08 September 2026

ŌHOKA FAST TRACK APPLICATION TRANSPORT RESPONSE TO INITIAL COUNCIL FEEDBACK

Attachment 1: Amended Site Plan and Cross-sections

A TYPICAL ROAD CROSS SECTION
22m ROAD WITH SWALE ON ONE SIDE
SCALE 1:50@A1 1:100@A3

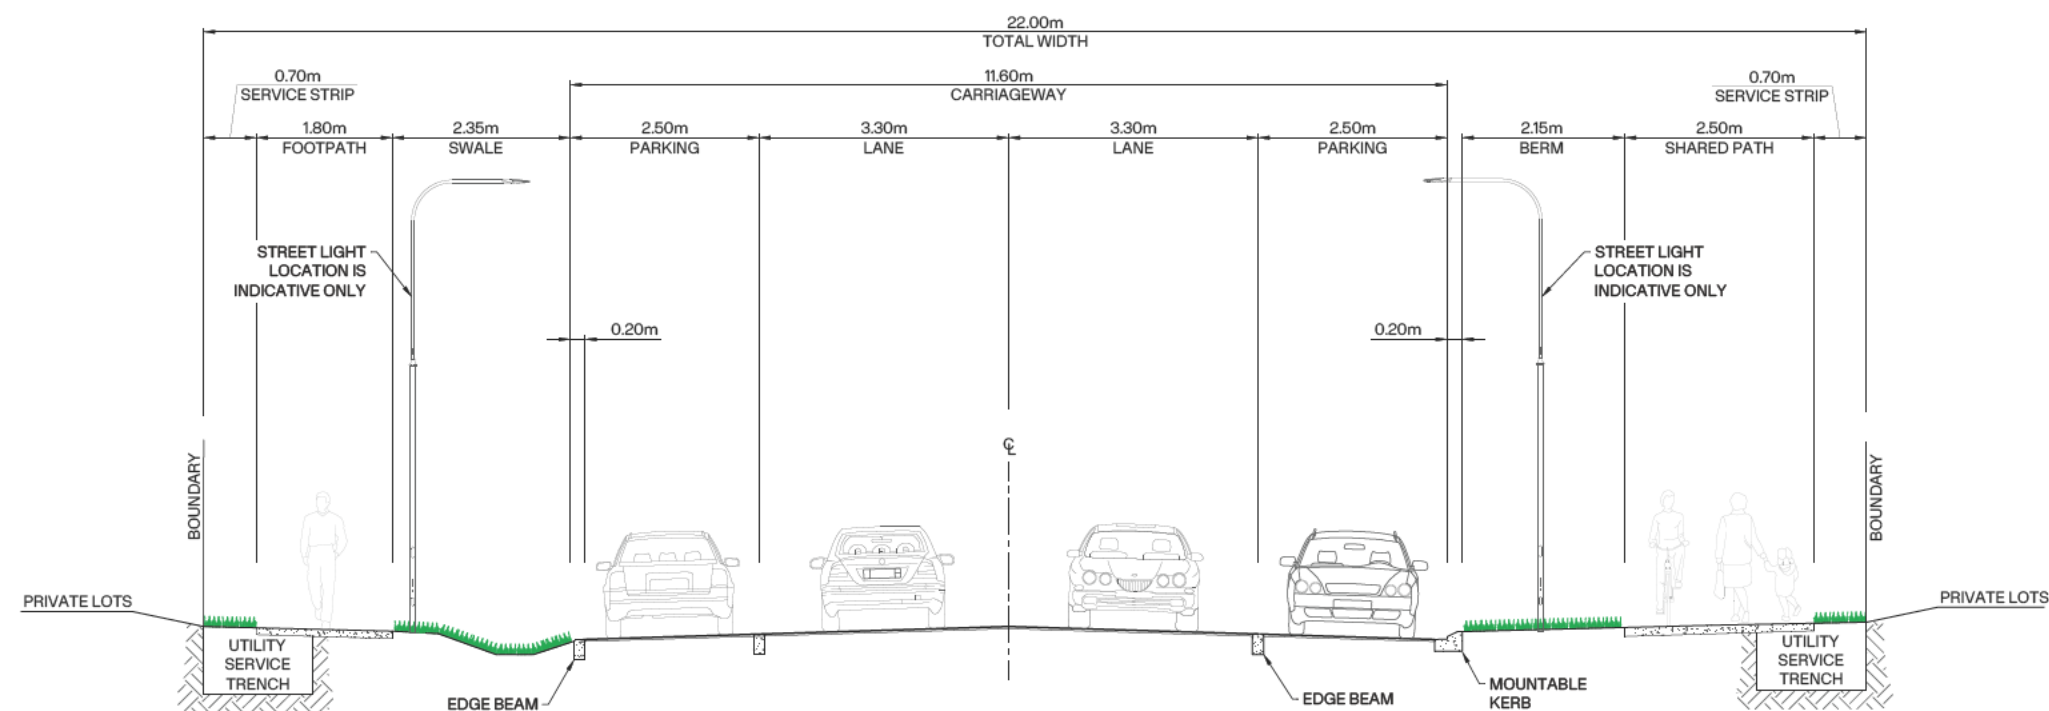
4.5m lane widths do not match Local Street standards in the PODP and are likely to result in high speeds. Traffic lanes should be 3.0-3.3m (wider on higher-function streets only) as per PODP Tables TRAN-3 and -4. However, on streets where additional space for parking is not provided, a 9.0m carriageway is appropriate; an 8.0m is the minimum required where no additional space is available for parking.

8. The 4.5m wide lanes were previously proposed on the 22m corridor roads, which are collector roads. The proposed collector road cross-sections (Type A, B and C in **Attachment 1**) have been updated to generally comply with the District Plan requirements of table TRAN-3 of the Partially Operative District Plan, with the following exceptions:

- a. The District Plan requires on-road cycle lanes, whereas none are proposed as it is intended that cyclists use the shared paths on the collector roads; and

- b. The District Plan requires a corridor width of 23m, where a width of 22m is proposed. That said, the transport elements are contained within the proposed corridor width (except the cycle lanes).

B TYPICAL ROAD CROSS SECTION
22m ROAD WITH SWALE ON BOTH SIDES
SCALE 1:50@A1 1:100@A3

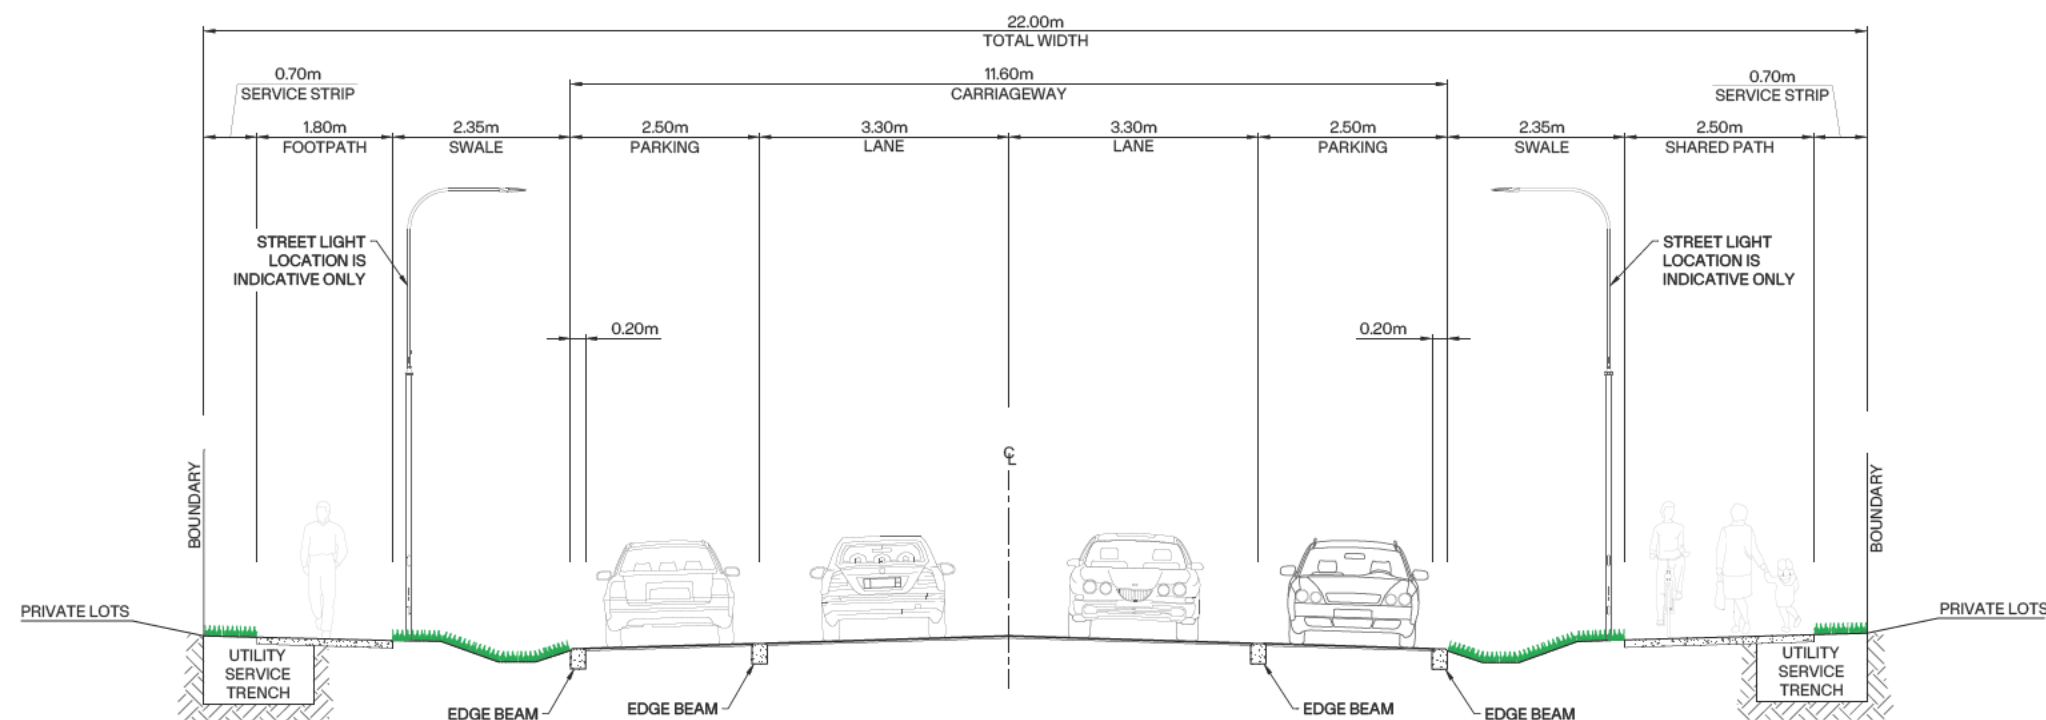
All cross sections with 2.5m paths should refer to them as “shared paths” to note that cycling is permitted; cycling is not permitted on footpaths.

6. These have been updated on the attached cross-sections.

TYPICAL ROAD CROSS SECTION
D 20m ROAD WITH SWALES ON ONE SIDE
SCALE 1:50@A1 1:100@A3

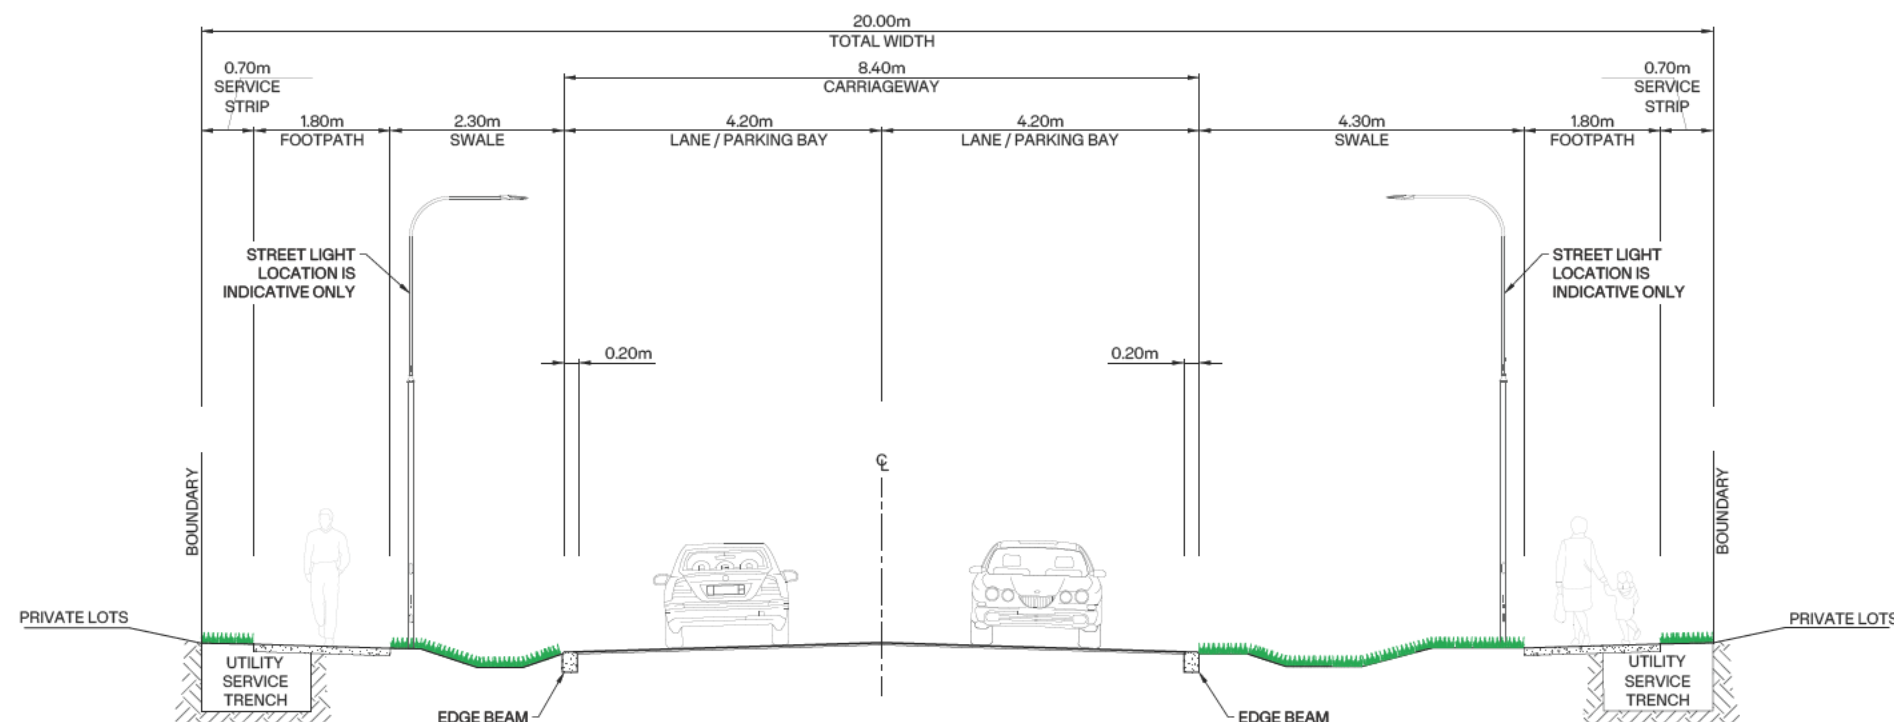
6.0-7.0m wide carriageways with no additional width for parking are not supported. Further, ITA para 96 suggests that Type D roads (with 7.0m carriageways) would not provide on road parking. While on-road parking demand is expected to be low in a large-lot residential area, Council’s Parking & Traffic Bylaw explicitly allows on-road parking in these areas and the assumption underlying the Type D cross section would not be supported.

9. The carriageway of the 18m wide roads (Type D, E and F in **Attachment 1**) have been amended to be 8.4m wide (including on-street car parking), where this was previously 7m wide plus additional space for indented car parking. The proposed 8.4m carriageway width is slightly wider than permitted by the District Plan, which permits an 8m carriageway (including 2.2m of on-street car parking within the carriageway). The rationale for the 8.4m carriageway width is that it accommodates a 2.2m width of parking both sides of the road and retains a clear width of 4.0m for refuse collection or emergency services. This marginal additional width is not anticipated to lead to adverse effects, noting that on-street car parking will keep vehicle speeds low.

10. The Type D cross-section has been revised as described in paragraph 9 to provide for on-street parking within an 8.4m carriageway. The minimum remaining carriageway width is 6.0m on Type E roads, which are classified as Low Volume Local Roads and for which a 6.0m carriageway is permitted by the District Plan.

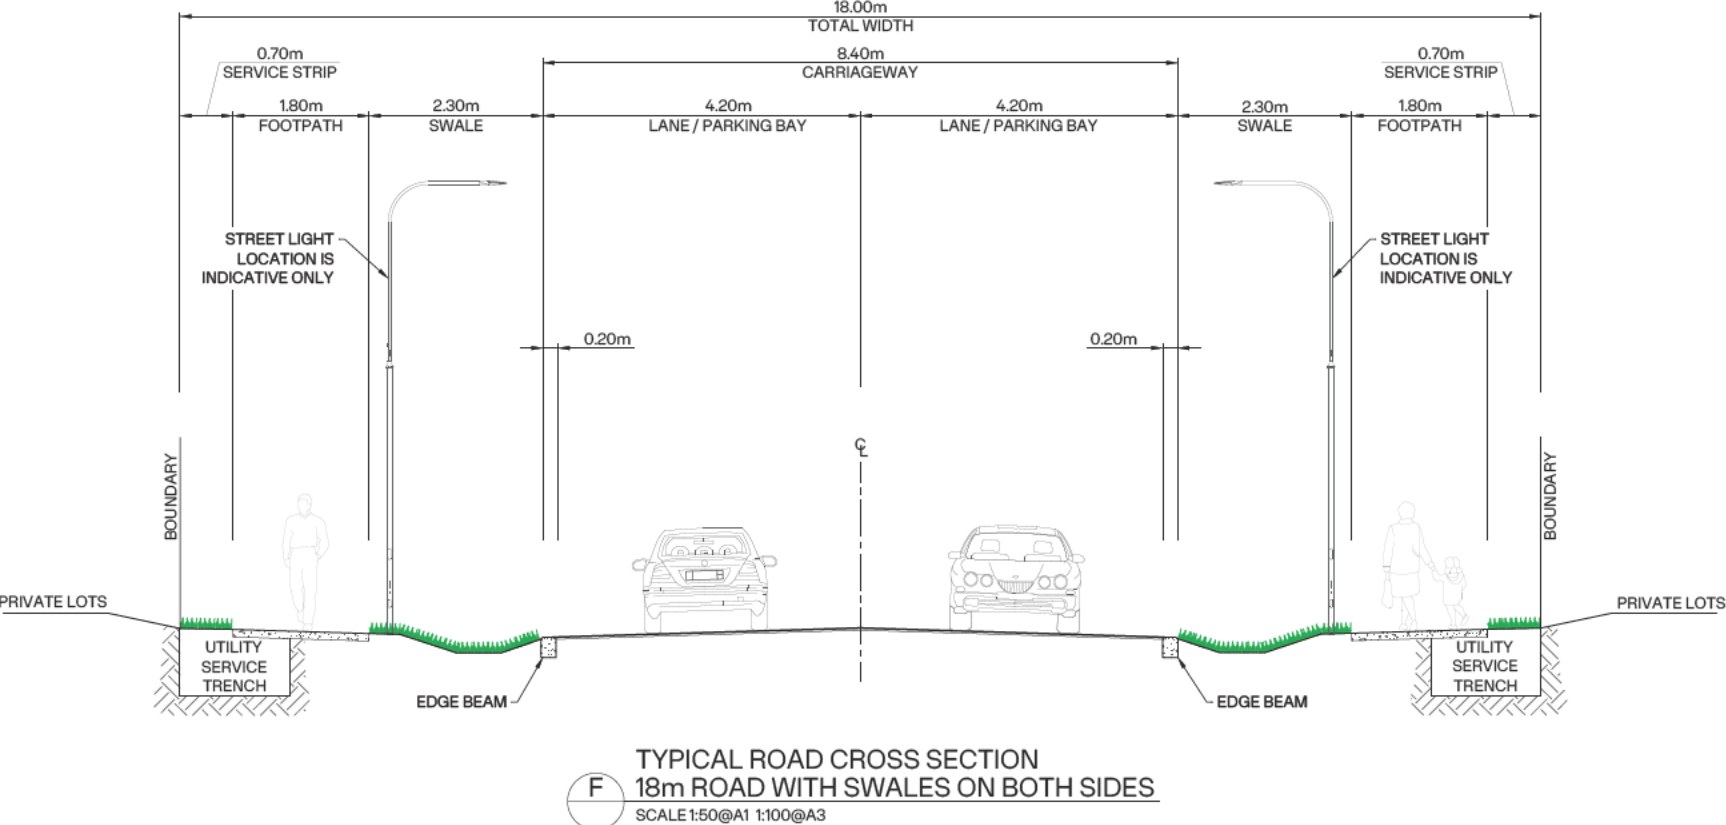
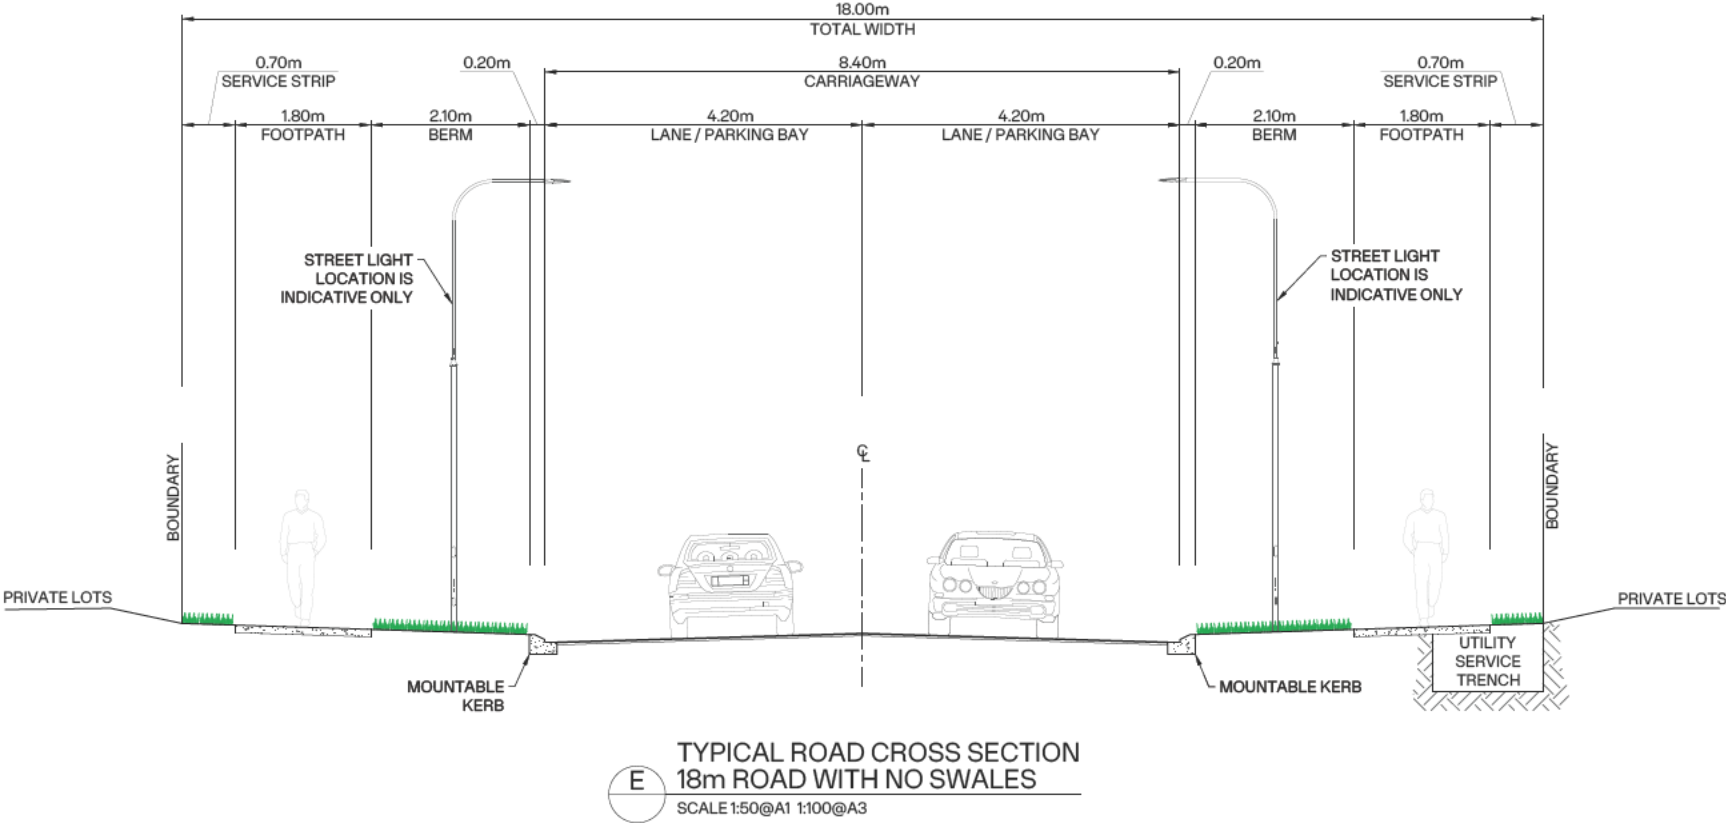
Widespread lengths of streets with footpaths on one side only is counter to a recent change in the PODP, has traffic safety effects of increasing walking in the street and/or unnecessary street crossings, and is not supported at the proposed scale.

13. The Council's comment relates to the Type E cross-section. That cross-section has been revised to provide a footpath on both sides of the road.
